**ADDENDUM NUMBER TWO**  
**RFQ # 7461328**

**TITLE: Construction and Renovations of Colt State Park Fishing Pier,  
Bristol, RI**

State of Rhode Island  
DEM-Planning and Development Contract No. 9-12  
Bid Number 7461328  
Construction and Renovations of Colt State Park Fishing Pier  
Bristol, Rhode Island

**DATE of ADDENDUM:** April 15, 2013

SK-1 PILE DOLPHIN DETAIL

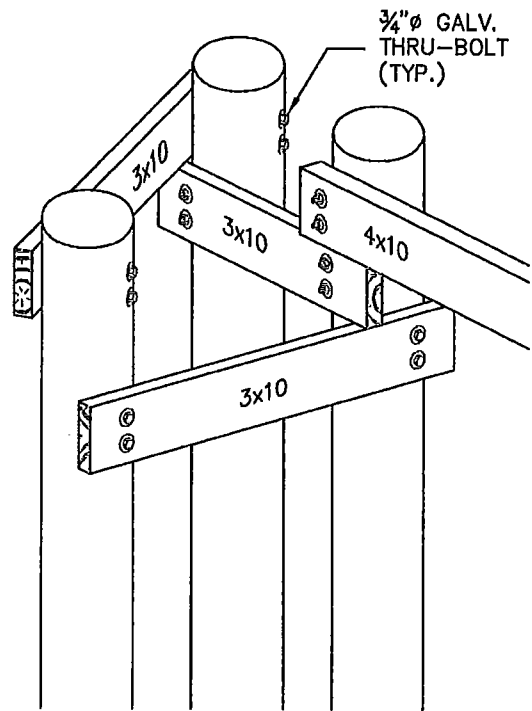
Q2) *What is the diameter of the cable that wraps the dolphins?*

Q3) *How many wraps of cable does each dolphin get?*

Q8) *What is the hardware securing the gangway support timbers that are bolted to the float piles?*

The dolphin piles shall be wrapped with 6 turns of 3/4" diameter stainless steel wire rope and thru-bolted to the king pile with two 3/4" diameter galvanized thru-bolts as shown in attached plan "SK-1 Pile Dolphin Detail".

The support timbers bolted to the float piles shall be secured with 3/4" galvanized thru-bolts as shown in attached plan "SK-1 Pile Dolphin Detail".

6 WRAPS OF  $\frac{3}{4}$ "  $\phi$   
S.S. WIRE ROPE  
STAPLED TO EACH PILE  
AT EACH TURN

SK-2 REVISED FRAMING ON EXISTING T-SECTION

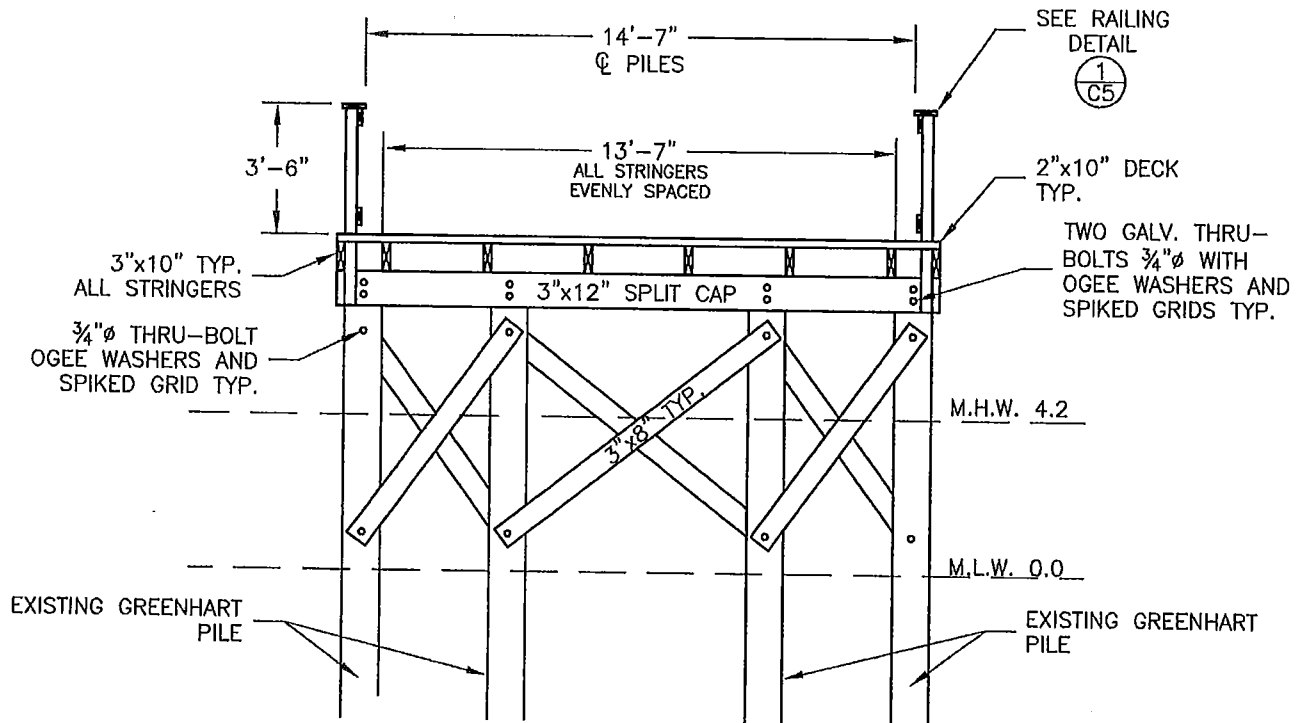
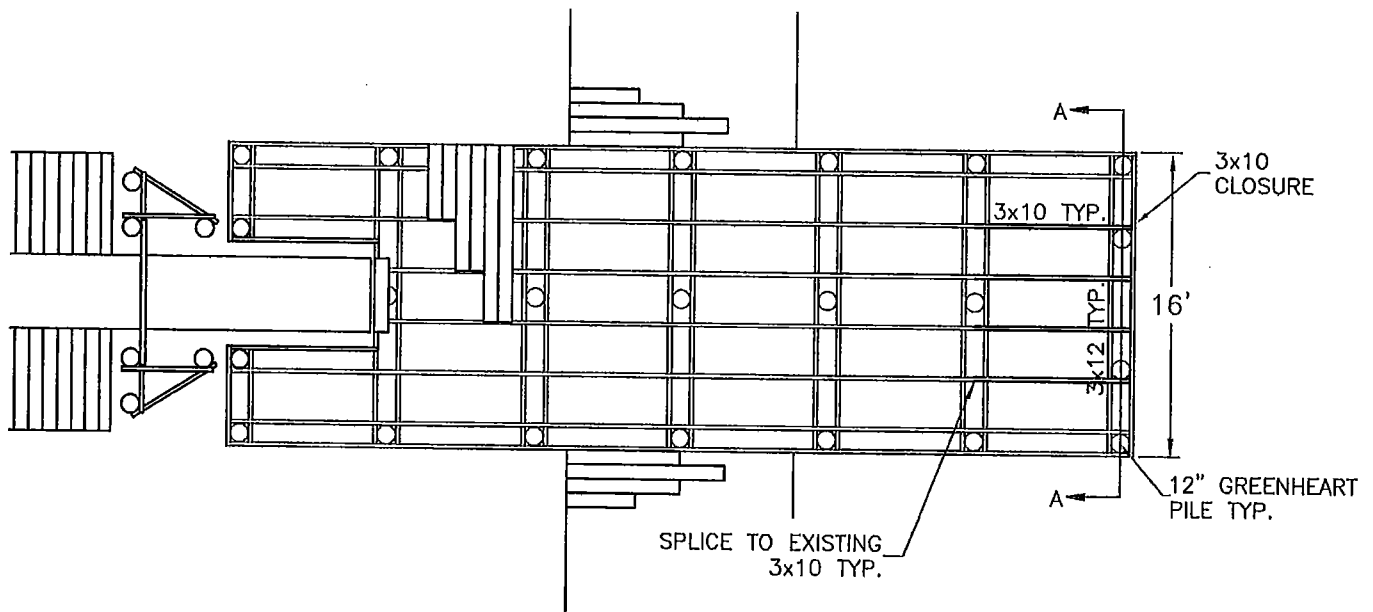
- ITEM C)** **Replace** all 3/8” diameter bolts with 1/2” diameter galvanized timber bolts with dome heads and 3” O.D. galvanized dock washers.
- ITEM D)** See attached SK-2 for a revised framing plan on the existing T-section.

*Q20) Please confirm that X-bracing is not required unless specifically identified on Drawings.*

Cross bracing will be required wherever specified on the Contract Documents including the cross bracing indicated in “SK-2 Revised Framing on Existing T-Section”.
